DEVELOPMENT REVIEW COMMITTEE (DRC) COMMENT REPORT

MEETING DATE: February 27, 2018

PROJECT NAME: 11th Street Townhouses

REQUEST: Site Plan Level II Review: 8 Residential
Townhouse Units

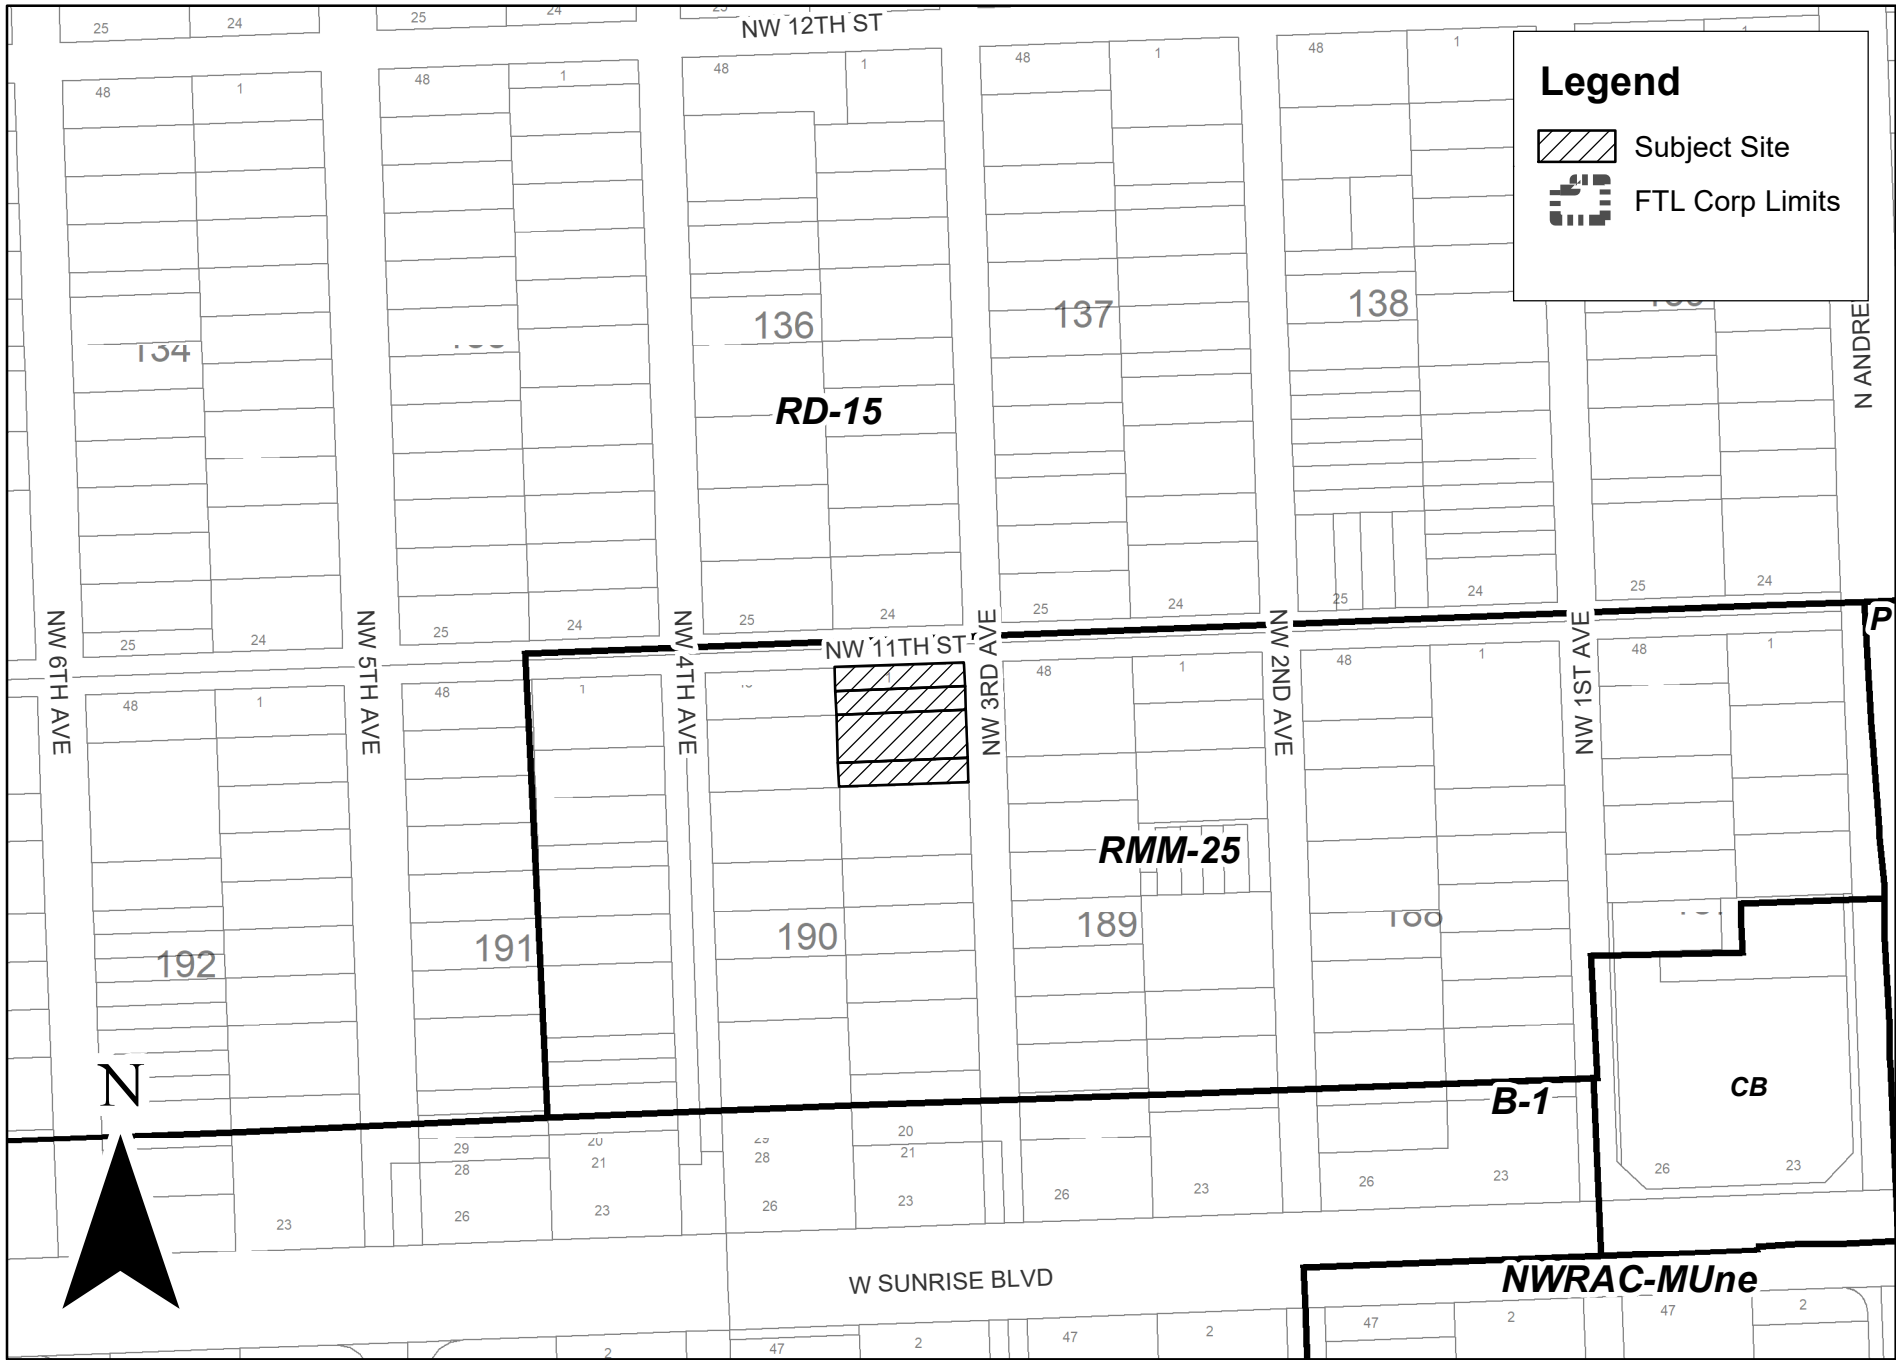
- a. A roofed landing, an architectural design and material similar to and integral with the principal structure,
 - b. A minimum of four (4) linear feet shall be provided between principal entrances,

- c. The roofed landing may encroach into the front yard an additional three (3) feet,
 - d. For individual dwelling units facing more than one (1) right-of-way, only one (1) entrance shall be required.
